EIR ADDENDUM

Gibson Solar Farm Project

Use Permit ZF #2020-0043
(SCH: 2021100191)

February 2026

Figure 1. Construction Sketch

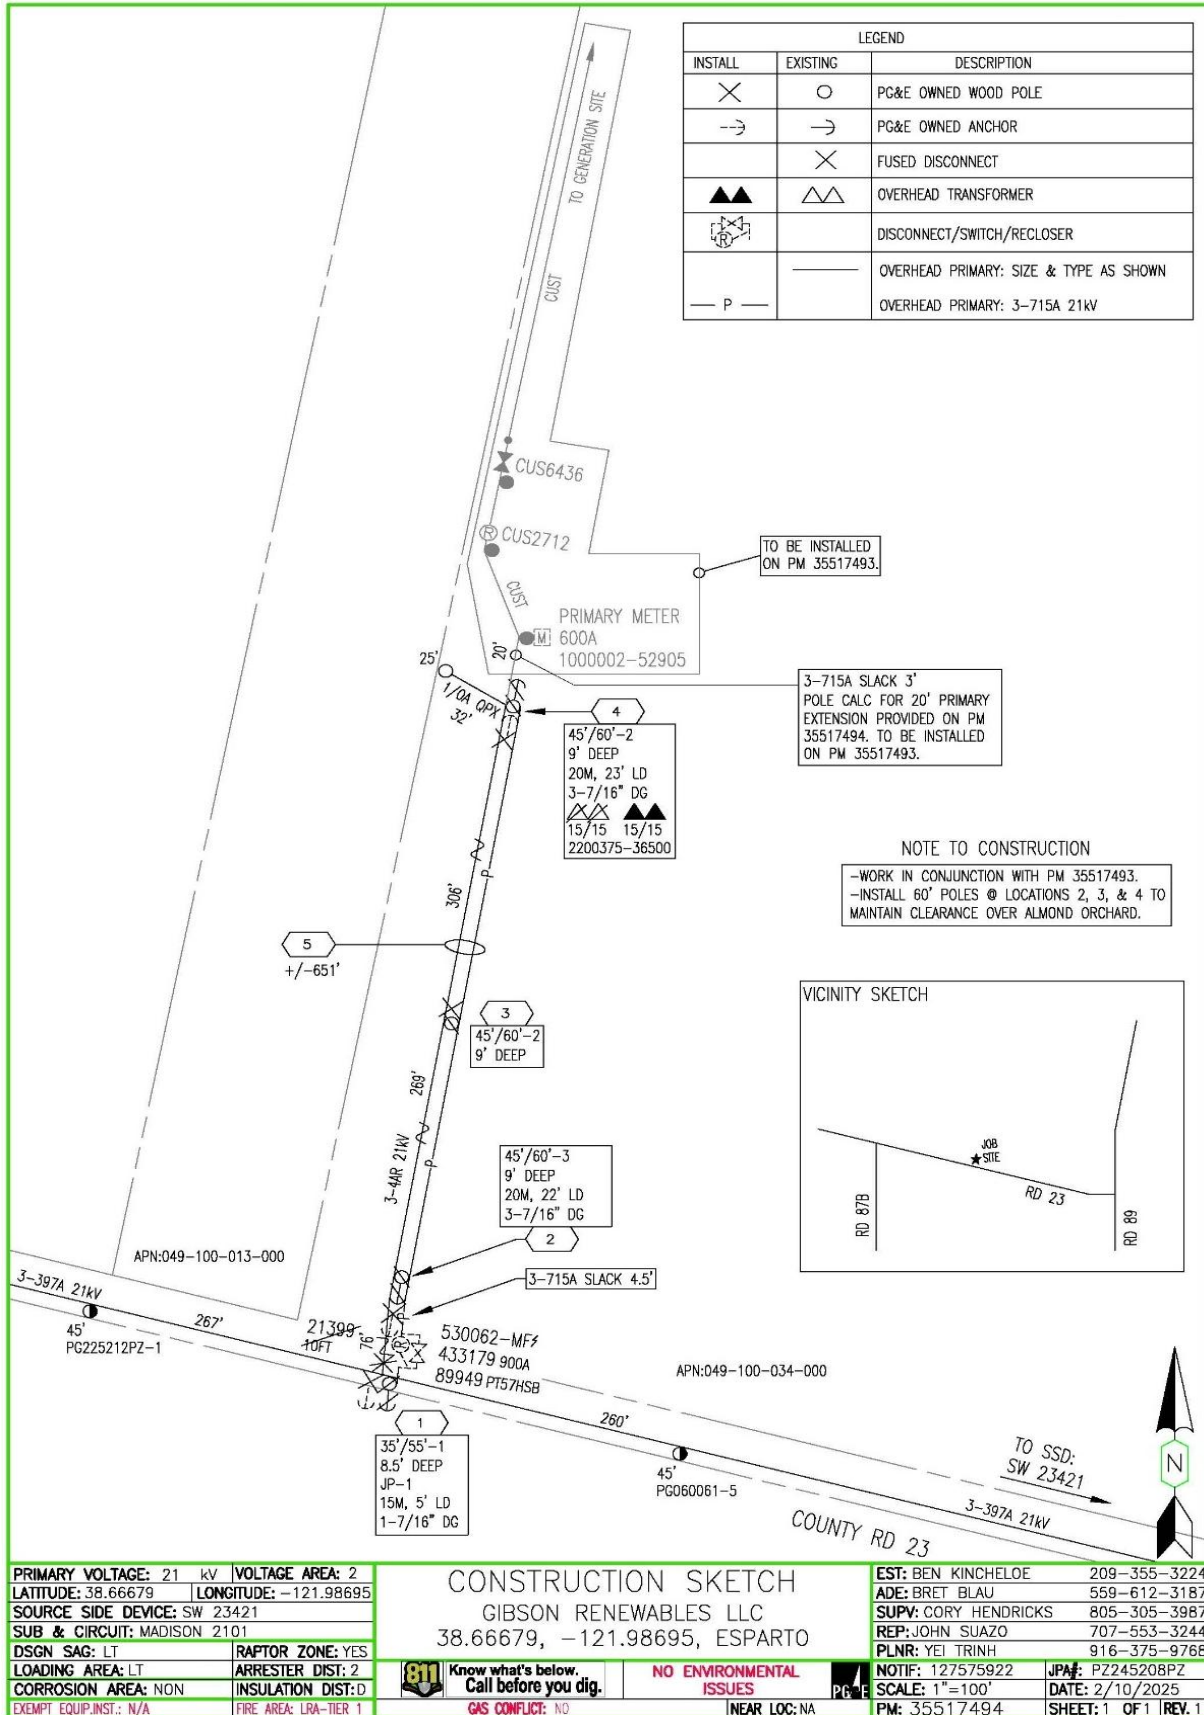
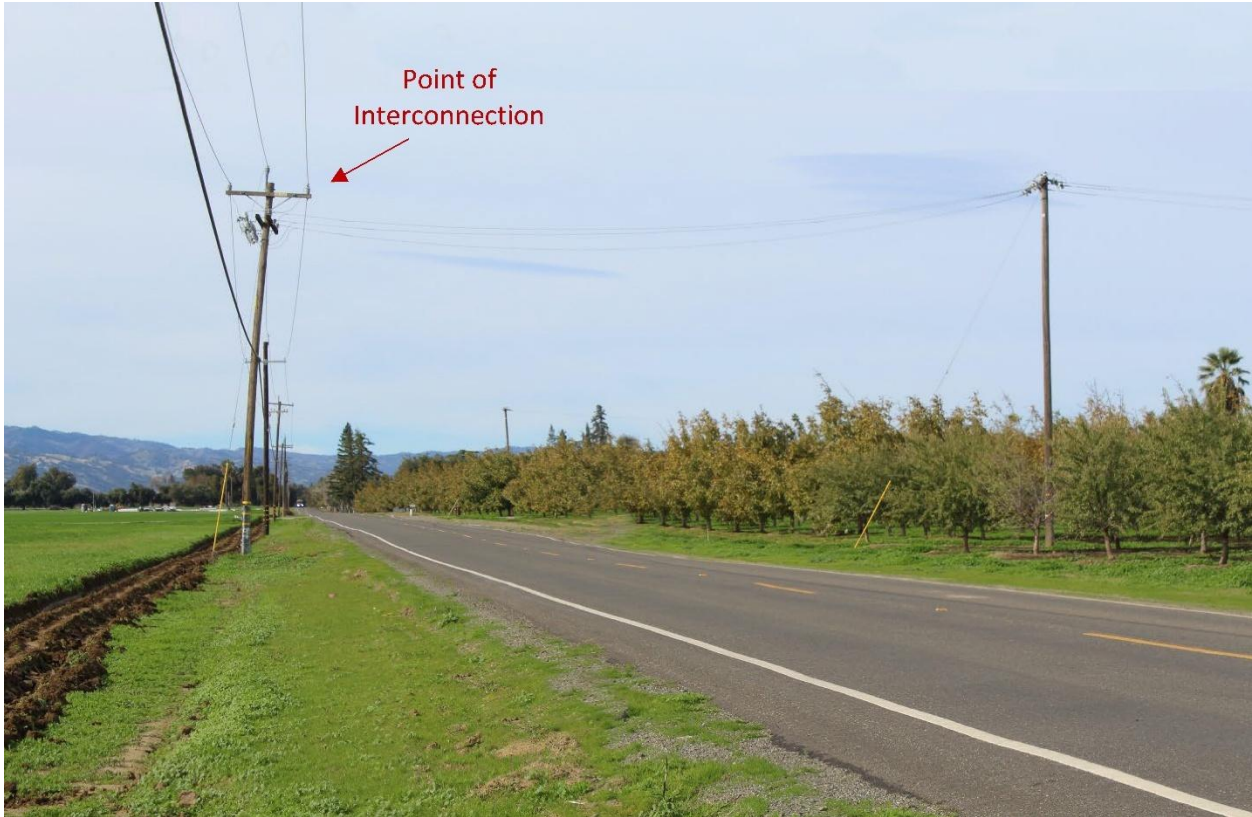
The “project” that is the focus of this Addendum is an evaluation of the proposed change to the height of the gen-tie line by an increase of 24 feet and replacement of four existing power poles to increase the height by 11.5 feet for the point of interconnection pole (labeled #1 in Figure 1) and 6 feet for the remaining three poles (labeled 2, 3, & 4 in Figure 1). The analysis in Table 1 provides the evaluation of the proposed changes and demonstrates that the circumstances, impacts, and mitigation requirements identified in the 2023 Gibson Solar Farm EIR remain substantively unchanged by the proposed height changes, such that an Addendum is warranted under Section 15164.
